**ON-SITE SEWAGE DISPOSAL SYSTEM  
 HOWARD COUNTY HEALTH DEPARTMENT  
 BUREAU OF ENVIRONMENTAL HEALTH**

ADDRESS: 7398 Gaither Road, Sykesville PHONE NUMBER: 410-549-4987

ADDRESS: 15005 Scottswood Court PROPERTY OWNER: ~~Joseph Cutroneo~~ Joseph Cutroneo  
~~Joseph Cutroneo~~ Katie Miles, c/o N Dorsey

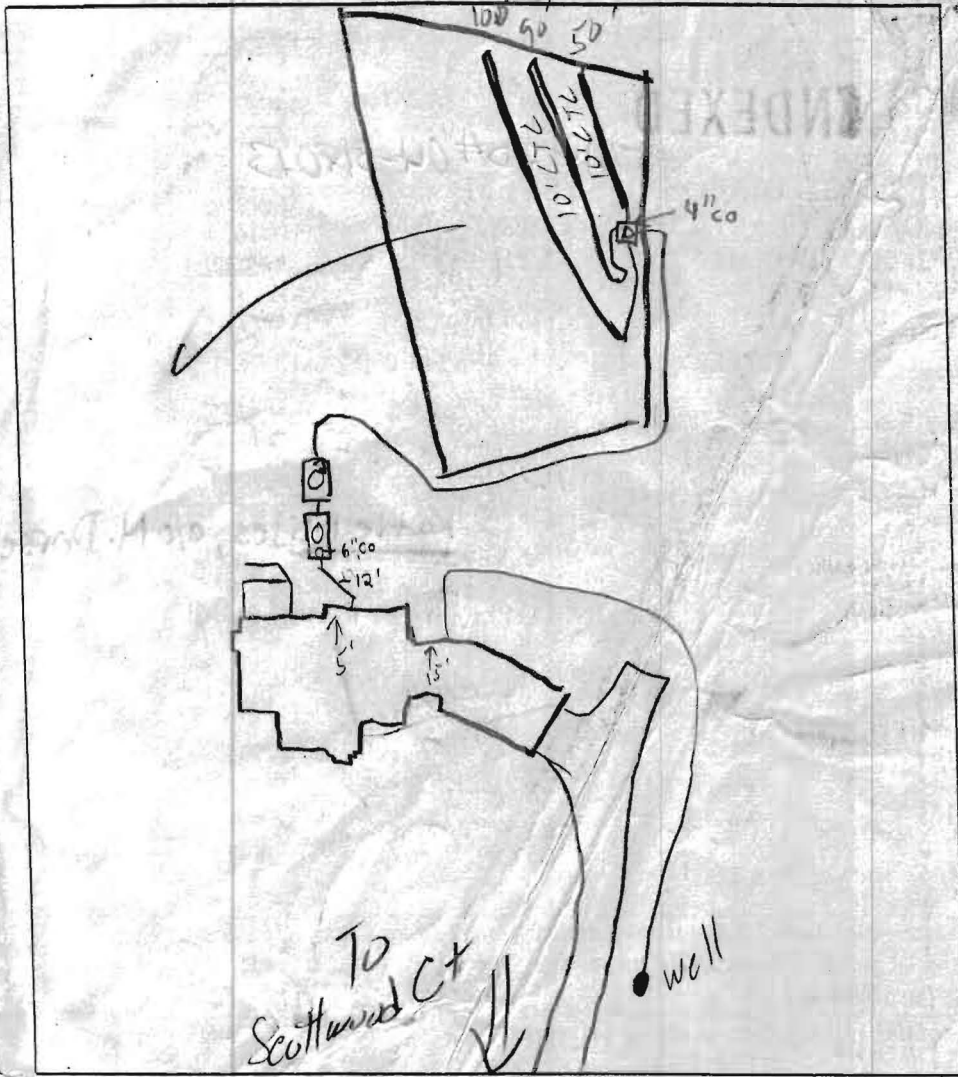
INSPECTION COMMENTS: 8/23/02 Lot staked, contours appear accurate.  
Log of per BP, tanks will be moved for less cover. Hence changed (50)  
8/27/02 OK to cover all work. Pump & Alarm test needed (50)  
11/12/02 Pump functional, Alarm not working. Grade around tanks  
needs to be fixed. Surface water going into P.T (50)  
11/15/02 - ALARM FUNCTIONAL, PUMP NOT WORKING - (50) 12/18/02 Pump OK (50)
